PLANNING REPORT

Planning & Zoning Commission

PENZONE – LIVE/WORK BUILDING 23-107CP

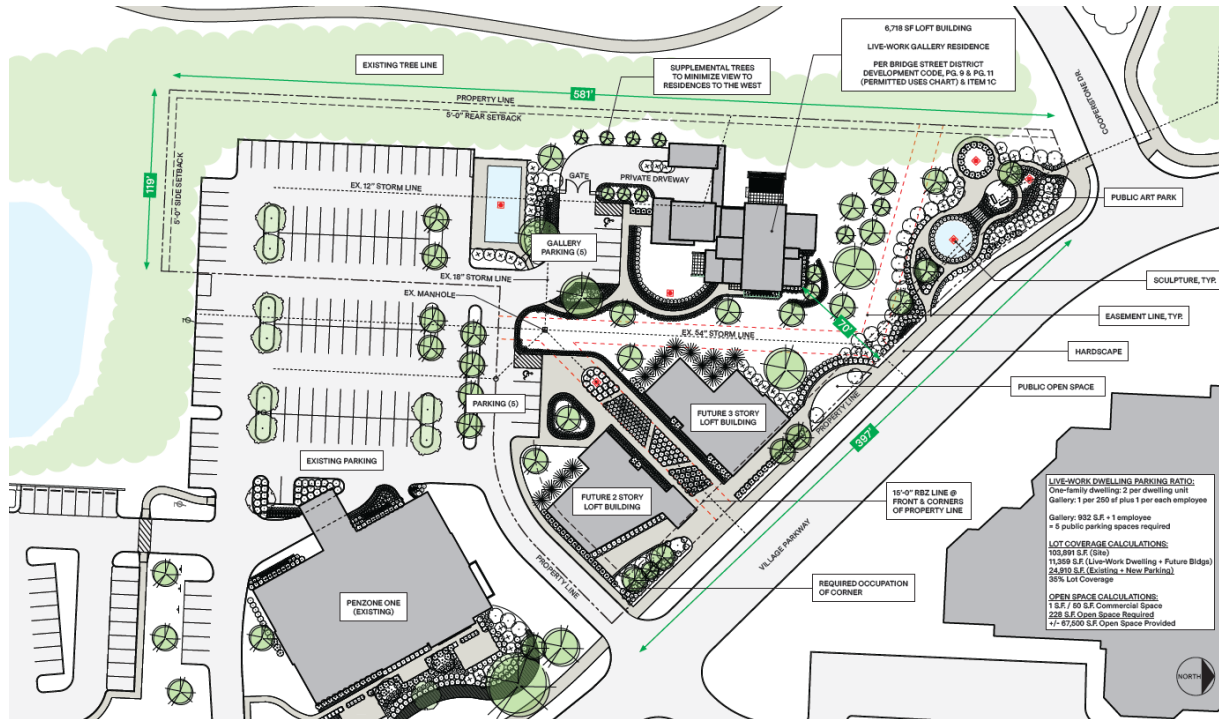
The applicant has made updates to the layout and location of the new building, slightly changing the orientation of the building and bringing it closer to Village Parkway. The 2,968-square-foot Loft building is sited centrally in the northwest portion of the parcel, setback 70 feet from Village Parkway. It should be noted that the 2,968-square-foot loft building does not include the square footage of the attached gallery and detached storage building.

The location of the building is limited by existing utilities and easements throughout the site, impacting the ability of meeting siting requirements along Village Parkway. However, Staff is not supportive of the current location and orientation of the building. The current configuration of the building does not address the Village Parkway as a Principal Frontage Street, does not accommodate pedestrian-oriented connectivity and continuity to the Village Parkway streetscape, and separates itself from the urban intent of the district.

| 5. The conceptual building is appropriately sited and scaled to create a cohesive development character, completes the surrounding environment, and conforms with the Building Types in the Code. | Criteria Not Met. The building is setback approximately 70 feet from Village Parkway, which does not meet the building siting requirements for Loft buildings. Although the site has constraints for the location of the building, the proposed building is not sited to meet the intent of the requirements to establish an urban, walkable development character along Village Parkway. |

- 1) Move the building north on the site, abutting the storm easement. This would allow for the building to better meet the intent of creating an urban form on the site.
- 2) Modify the orientation of the building to provide the public entrance on the north/northeast elevations of the building to align with the requirements for entrance locations.
- 3) Tie the building design into the design of the proposed public park. This would allow for integration of pedestrian circulation with Village Parkway, and better address the Village Parkway frontage.

- 1) The applicant work to move the building closer to Village Parkway to meet the intent of the siting requirements of the Bridge Street District;
- 2) The applicant modify the orientation of the building to provide the public entrance on the north/northeast elevations of the building to align with the requirements for entrance locations;
- 3) The applicant work to incorporate the building design into the design of the proposed public park to allow for integration of pedestrian circulation with Village Parkway, and better address the Village Parkway frontage; and,
- 4) The applicant continue to work with Engineering to demonstrate stormwater management compliance in accordance with Chapter 53 of the Dublin Code of Ordinances.
